**FOUNDATION TREATMENT & COMPACTION OF EARTHWORK**  
(Mainline US-54 & Ramps without Retaining Wall)

No.	Revisions	By	Date
CITY OF WICHITA			
FOUNDATION TREATMENT & COMPACTION OF EARTHWORK			
SEDGWICK COUNTY			
Professional Engineering Consultants, P.A. 303 S. TOPEKA • WICHITA, KANSAS 67202 316-262-2691 • FAX 316-262-3003			
Designed by	WDH	Checked by	WDH
Drawn by	JGP	Date	April, 2002
		Job No.	97362

**RECORD DRAWING**

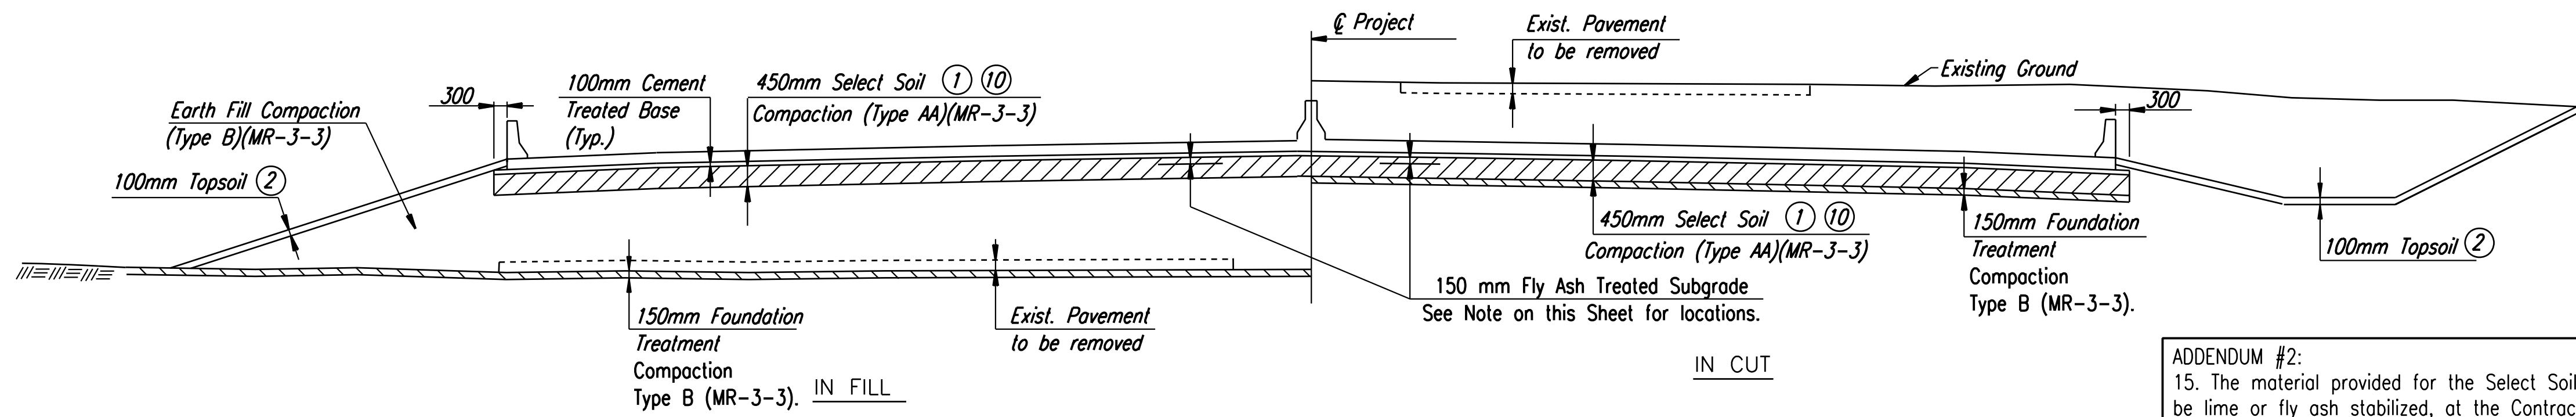
ADDENDUM #2:  
15. The material provided for the Select Soil in the top 450 mm may be lime or fly ash stabilized, at the Contractor option, in order to meet the specified requirements. This work shall be performed off-site in accordance with KDOT specifications. Lime and/or fly ash stabilization will not be measured or paid for separately, should the Contractor decide to use this method, but shall be Subsidiary to the contract unit price bid for "Embankment (Contractor Furnished)".

**FOUNDATION TREATMENT & COMPACTION OF EARTHWORK**  
(Mainline US-54 & Ramps with Retaining Wall)

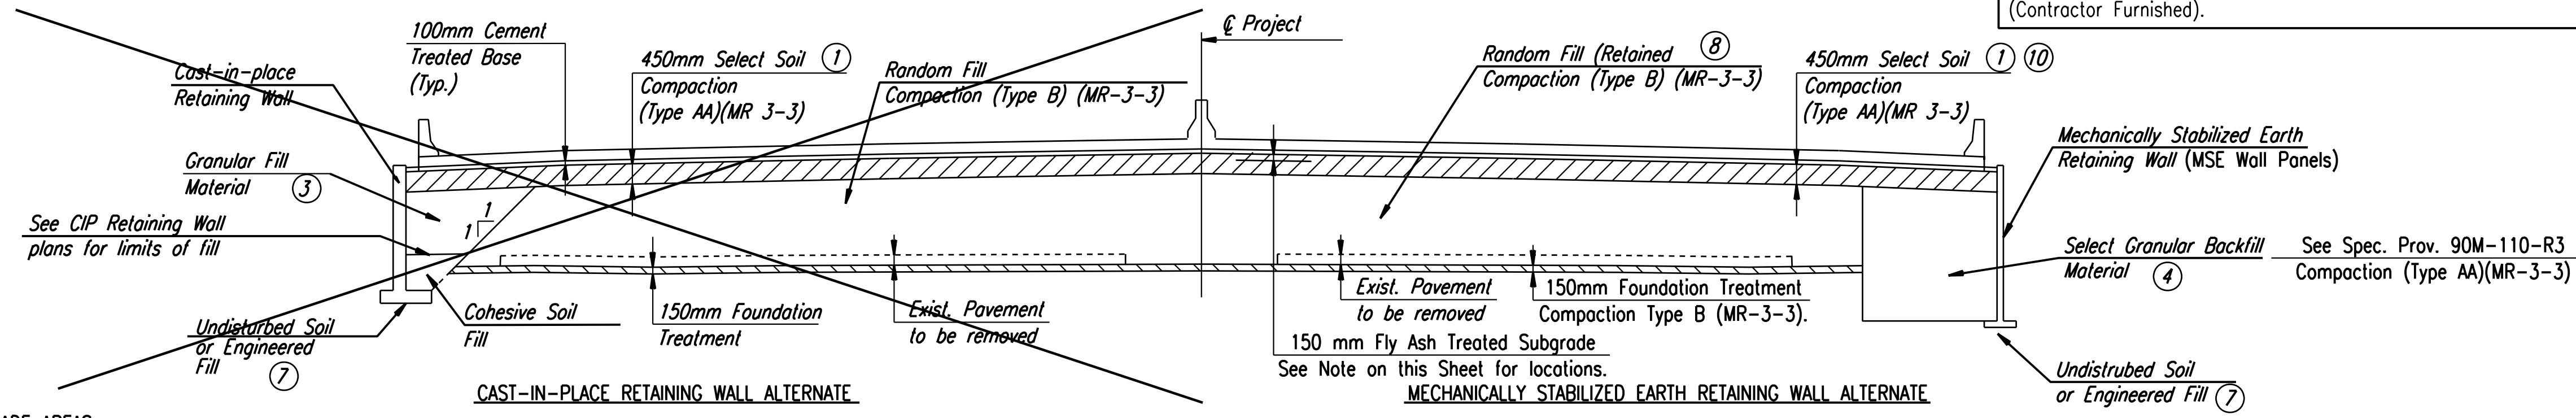
ADDENDUM #2:  
15. On-Site Common Excavation may be placed in lower 4 m of the random fill embankment area for the MSE retaining wall alternate. The MSE wall supplier shall take into consideration the use of this material, if done, in the wall system design.

⑩ FLY ASH TREATED SUBGRADE AREAS- TOP 150 mm OF SELECT SOIL:

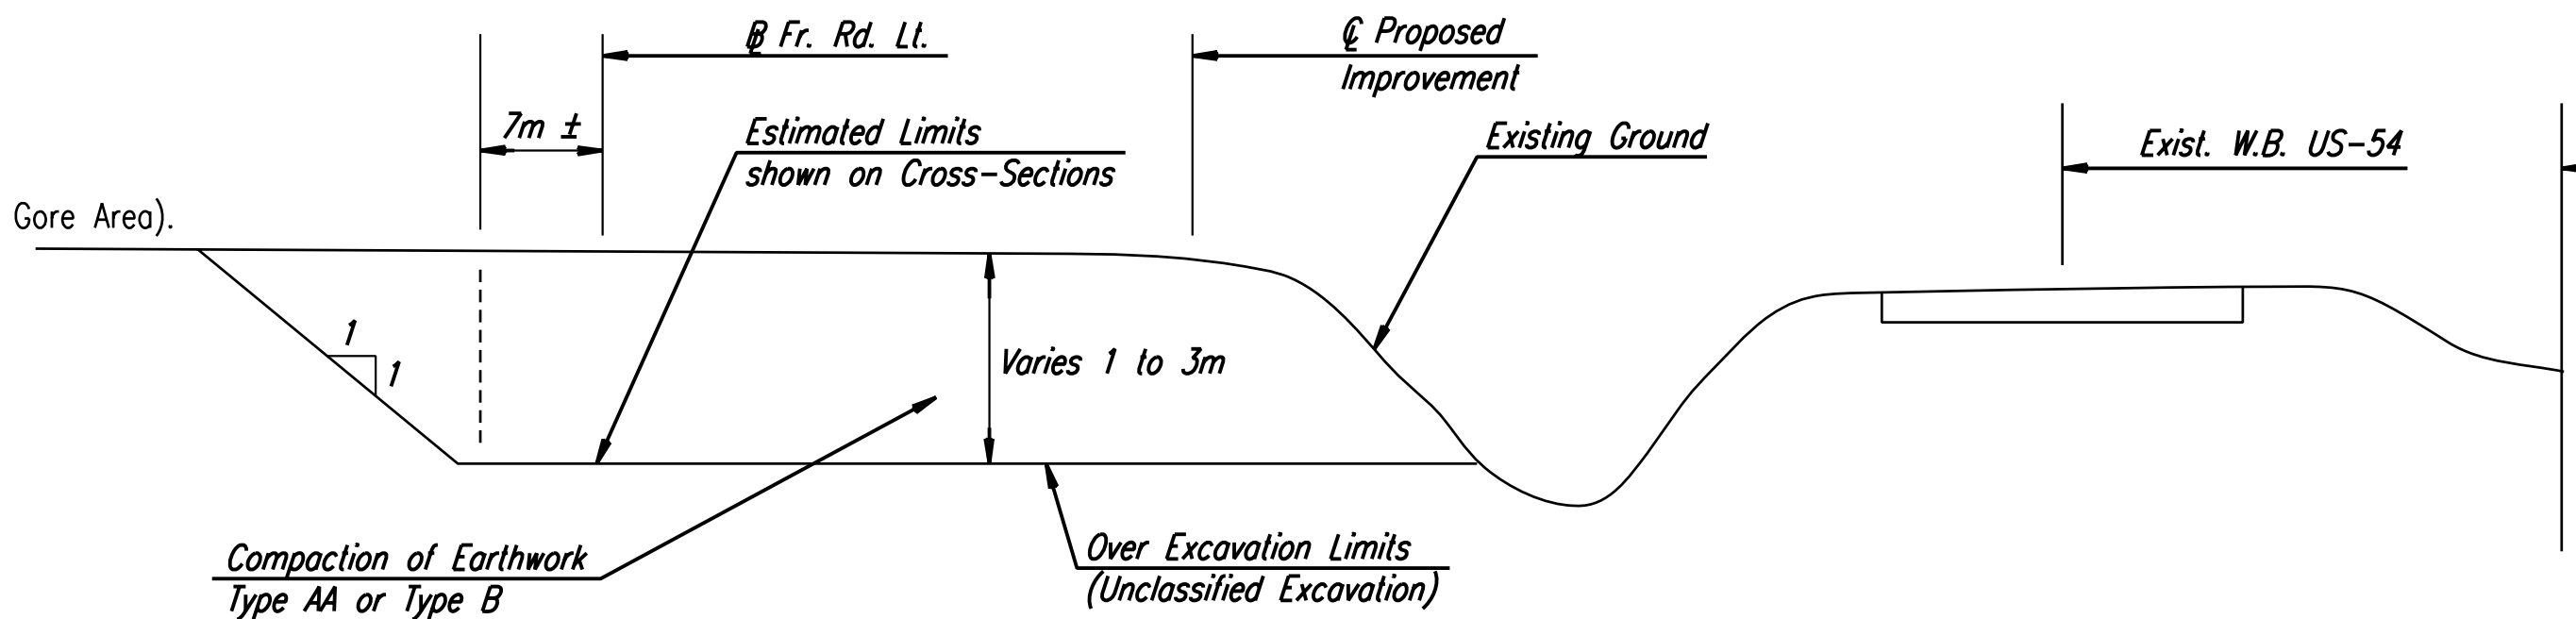
See P.E.C. Field Order Request #45, Wildcat Construction-Proposed Change Order Request #033-R and Change Order #2.
